Subject: HARD SHIFTING/SHIFT LEVER VIBRATION	Bulletin No: 05-001/15
	Last Issued: 11/30/2015

2012-2013 Mazda3 (SKYACTIV 6 M/T)

Location of Transmission Related Parts

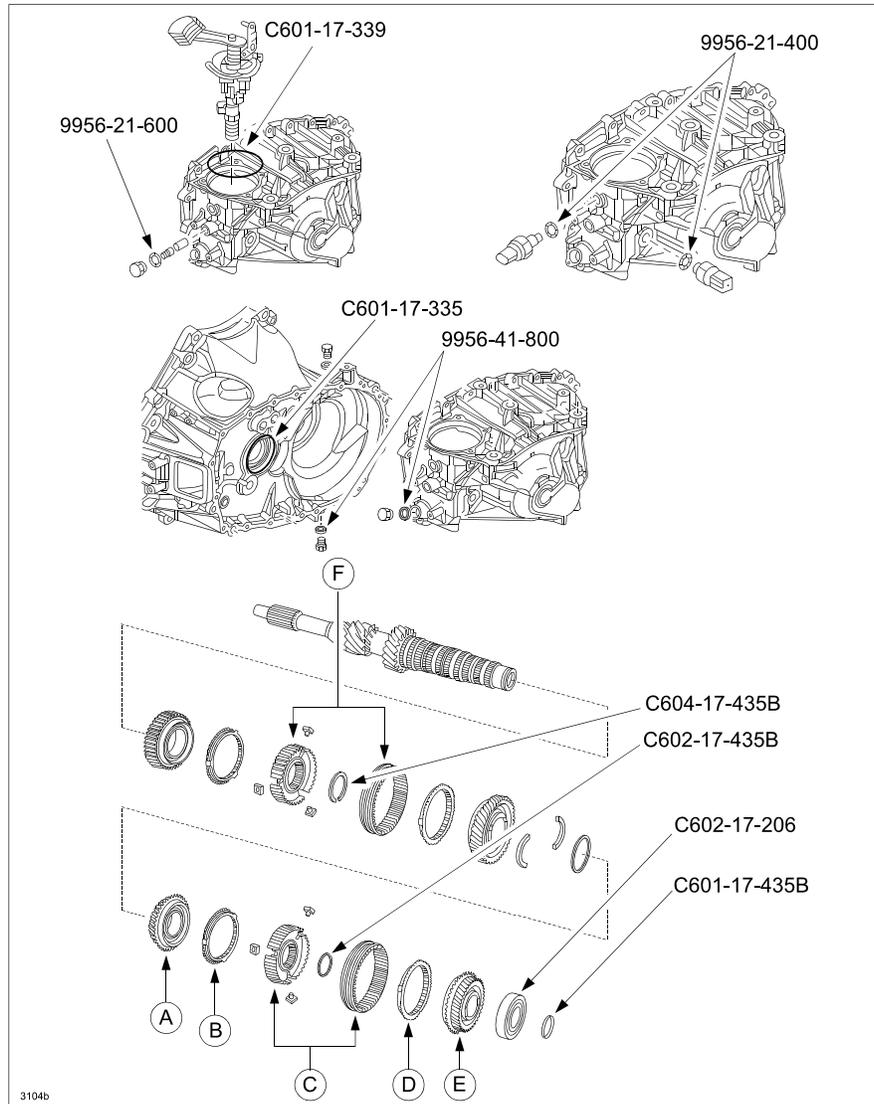
Modification	Mass-Production Change		Subject Concern
	Subject Part	Changes	
A	3-4 Clutch Hub	Surface treatment	Jumping out of gear
B	3-4 Clutch Hub 5-6 Clutch Hub	Shape	Hard shifting into 3rd, 4th, 5th and/or 6th gear
C	3rd and 4th Gears	Tolerance	Shift lever vibration
D	3rd and 4th Gears 3rd and 4th Synchronizer Rings	Shape	Hard shifting into 3rd and/or 4th gear (additional improvement)

VINs	Symptom			
	Gear jumping out (3rd Gear)	Hard shifting (5th or 6th Gear)	Hard shifting (3rd or 4th Gear)	Shift lever vibration (3rd or 4th Gear)
VINs before Modification A	Replace: 1) 3/4 Clutch Hub 2) 3rd Gear and Synch. Ring	Replace: 1) 5/6 Clutch Hub	Replace: 1) 3/4 Clutch Hub 2) 3rd Gear and Synch. Ring 3) 4th Gear and Synch. Ring	Replace: 1) 3rd Gear and Synch. Ring 2) 4th Gear and Synch. Ring
VINs between Modification A and B				
VINs between Modification B and C			Replace: 1) 3rd Gear and Synch. Ring 2) 4th Gear and Synch. Ring	
VINs between Modification C and D
